Statutory Planning Committee

ITEM NO: 9.1

Proposed Amendment to Port Coogee Local Structure Plan (Stages 3A, 5 and 6)

PROPOSED STRUCTURE PLAN – PORT COOGEE

Photographs of Stage 5

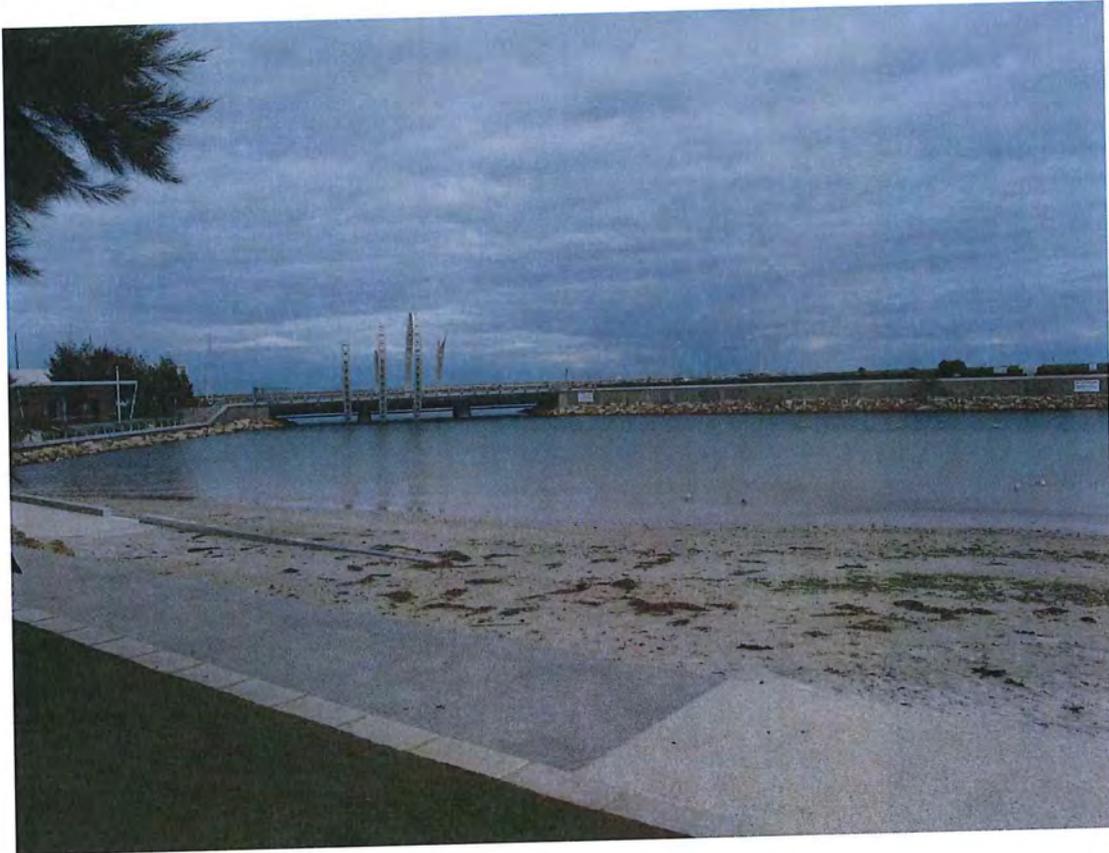
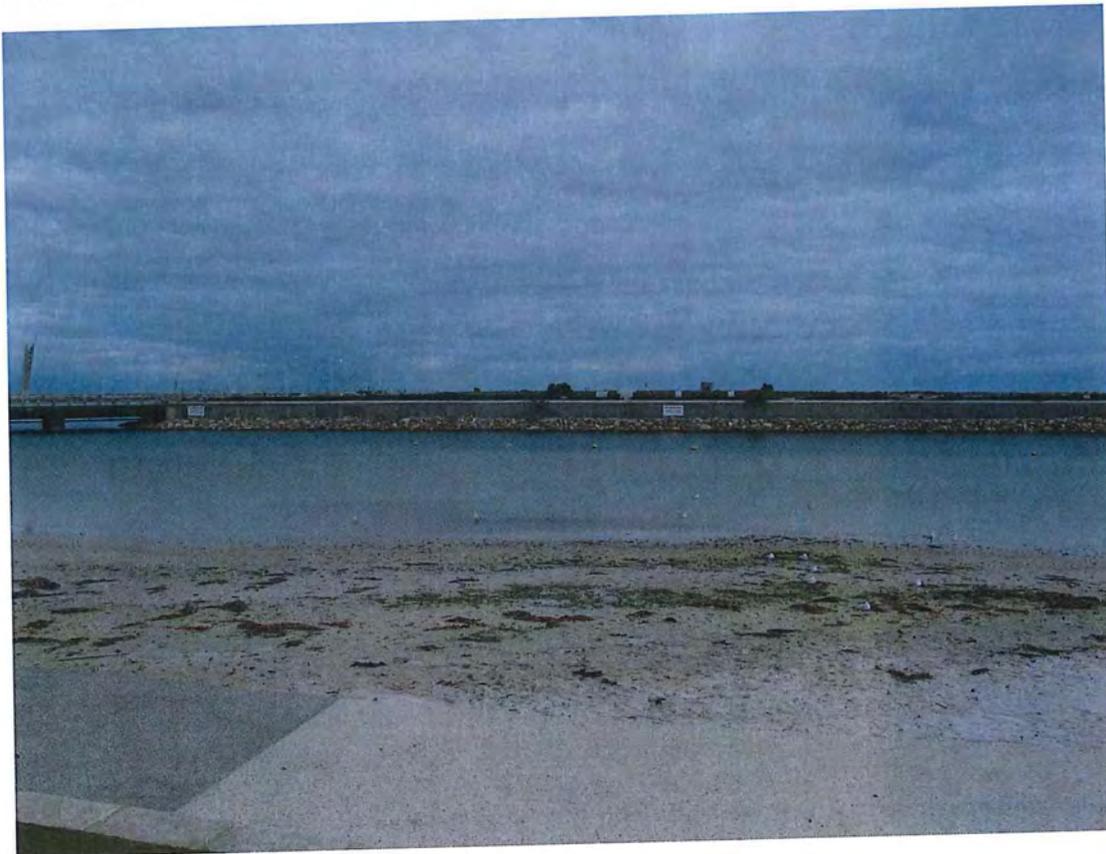
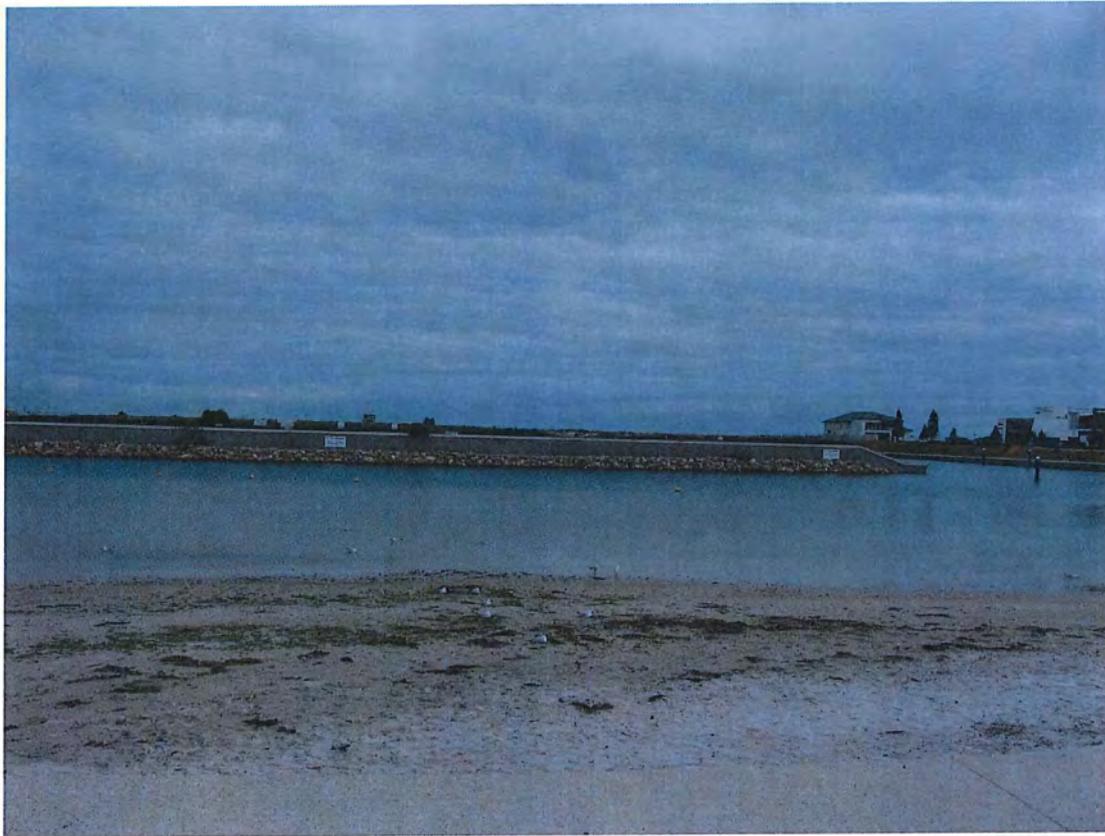
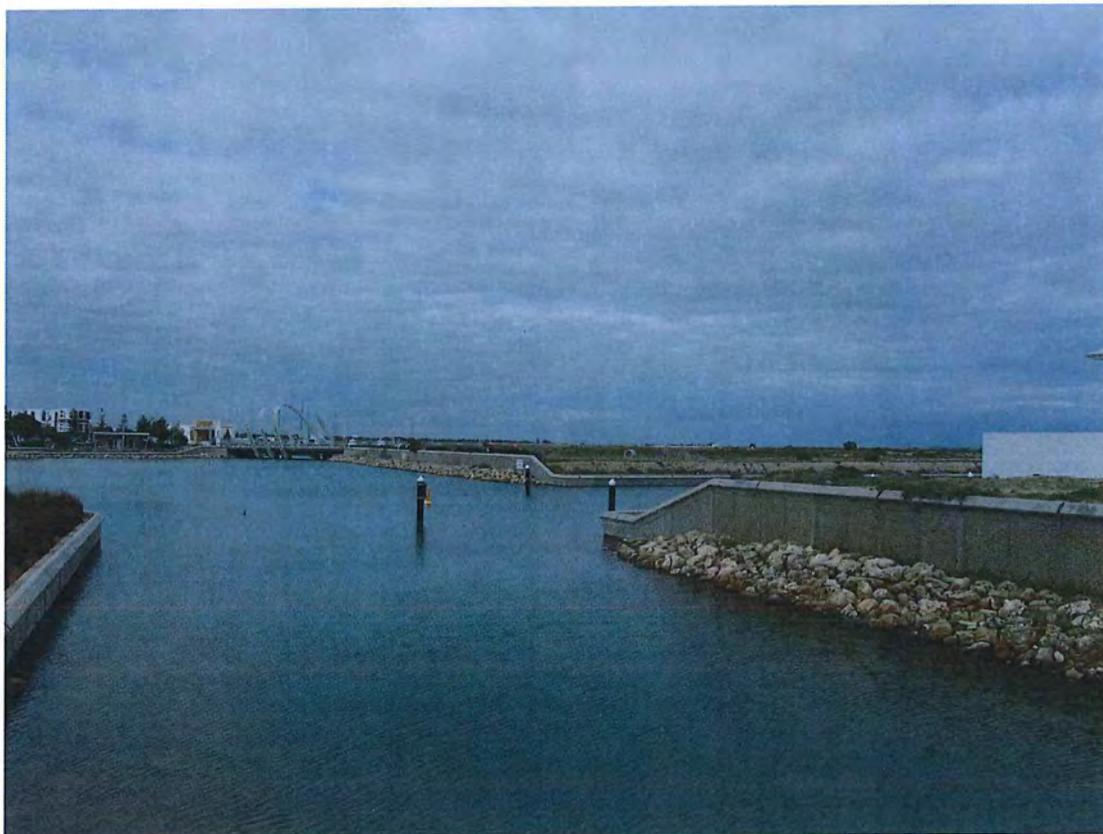
to provide any visual relief or reduce the apparent bulk of the building. As demonstrated in the Visual Assessment included in their letter dated 6 July 2016, the upper floor will still be visible from the beach. In addition, balustrading and the use of the balcony area, including possible 'shade cover' will effectively result in the building appearing 17.3m in height. This is not considered any degree of a compromise.

The City therefore seeks a more substantial setback to the upper floor that ensures the entire upper floor and the useable balcony area is also not visible from the public viewing areas so that the buildings heights genuinely appear to be 13.6m as shown on the adopted Structure Plan.

Figure 1. Current Structure Plan - R60 with maximum height of 13.6m, and public road access

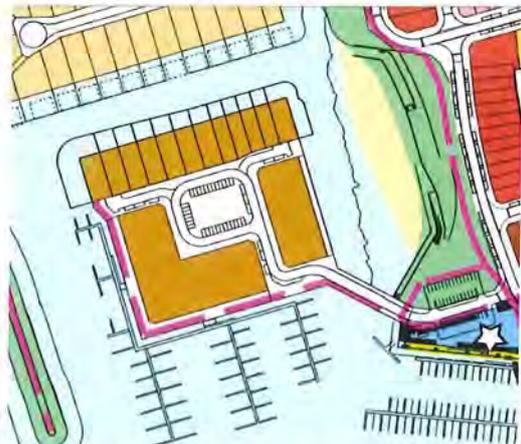
The current endorsed Structure Plan shows 'The Island' being accessible by a public road with a central parking area for visitors and boat pen licence holders (Figure 1). There are 8.0m wide pedestrian access ways included on the south, east and western sides, which are connected by a public road. This facilitates connectivity for pedestrians by creating a 'loop'. It also creates a sense of permeability and openness through the inclusion of public roads, which is considered to be in the spirit of the intent of the structure plan.

In comparison the current proposal includes only public access via a PAW on the southern and partially the eastern sides which does not provide pedestrians with a circuit.

Pedestrians will arrive to the north west of the area and be required to turn around and return the way they came. This is considered to create an uninteresting and undesirable route for pedestrians, also reducing the level of openness and public accessibility that has always characterised 'The Island', and the Structure Plan as a whole. This philosophy is demonstrated in Figure 3 'Marina Village Illustration' from the Structure Plan report, which reflects a permeable and open public road network.

To ensure this fundamental principal of public accessibility remains the City therefore recommends that the Structure Plan be modified to include public access in a 'circuit' to create an interesting and inviting pedestrian route, whether this is designed as a public access way and or public road.

Figure 7. Lots with no on-street parking for visitors within a reasonable distance

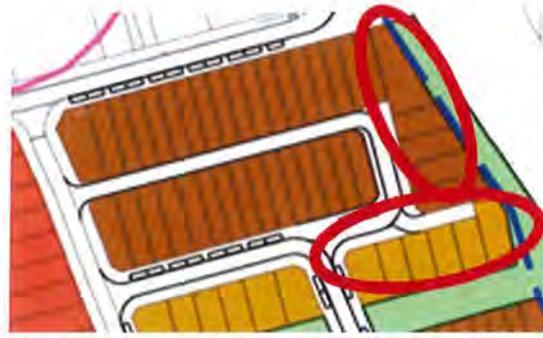
The L-shaped laneway and road connection (figure 6) creates an undesirable waste vehicle movement scenario whereby if a car is parked in the laneway, the waste vehicle must reverse around a corner. This is a situation that increases the likelihood of property/fence damage, and puts pedestrians in the laneway at risk.

Moreover, the road configuration in the north-eastern portion of the Structure Plan is considered dysfunctional in a way that will not just be problematic for waste vehicles. Proposed bin-pads on the opposite side of the adjacent road as shown in some of the sketches (Proponent sketch ii Detail D) approximately 50m away from the lots is a reflection of poor design that will create an undesirable situation for future residents of Lots 24-27 (as annotated on Sketch ii).

It is unclear where visitors will park in this area (lots outlined in Figure 7), and the City foresees ongoing problems with parking compliance should the Structure Plan be approved as proposed.

Therefore in addition to widening this northern laneway and including a 1m setback as proposed by the proponent to improve waste vehicle access, the City recommends that the road and lot configuration in the north-western section be re-designed. For example, a better outcome would be grouped or multiple dwelling site(s) for this area which can incorporate dedicated visitor parking and provide more flexibility to achieve the best design outcome.

ATTACHMENT 1 - REVISED CONCEPT
PLAN

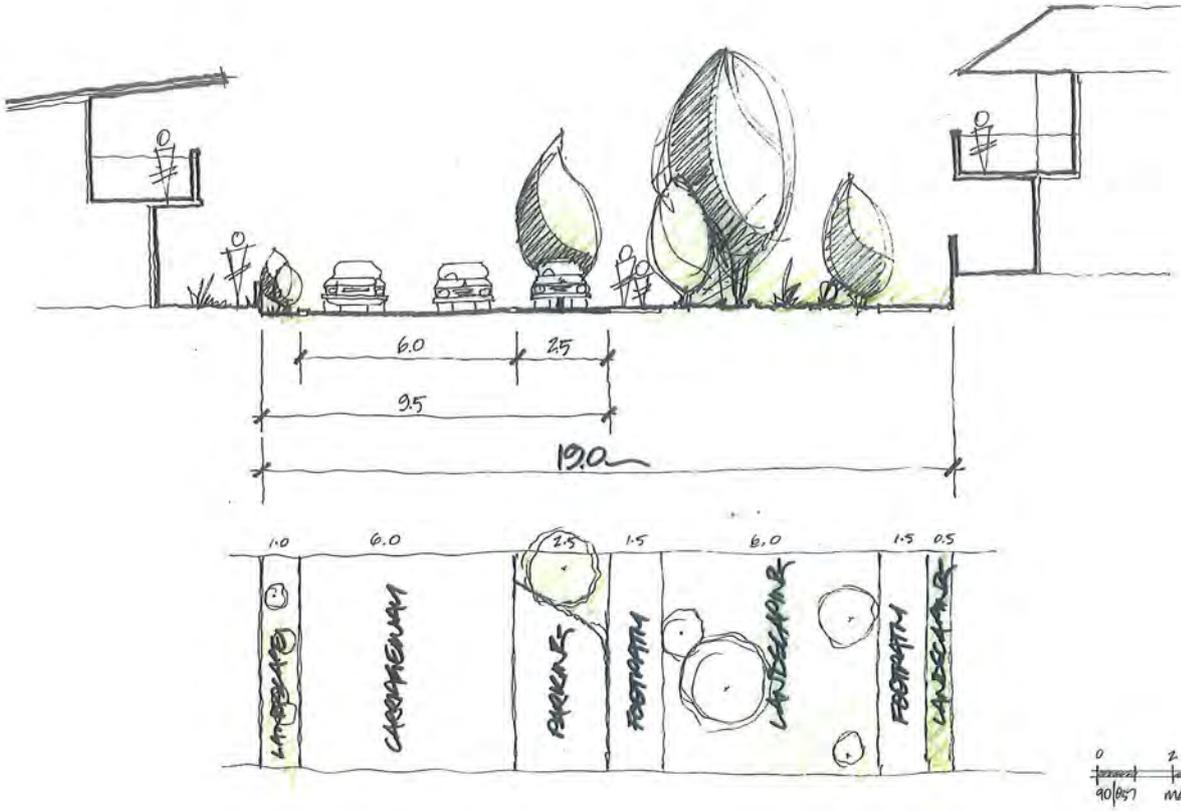
The City's email dated 10 April 2015 attached and referred to in the proponents letter referred to a specific revised concept plan for the southern portion of Stage 5 (Attachment 1 to this letter), whereby a pre-lodgement meeting and discussions were had regarding this southern section of the proposed Structure Plan only which was considered to be fatally flawed. Therefore the assertion that the City has supported this laneway design in the northern area is false.
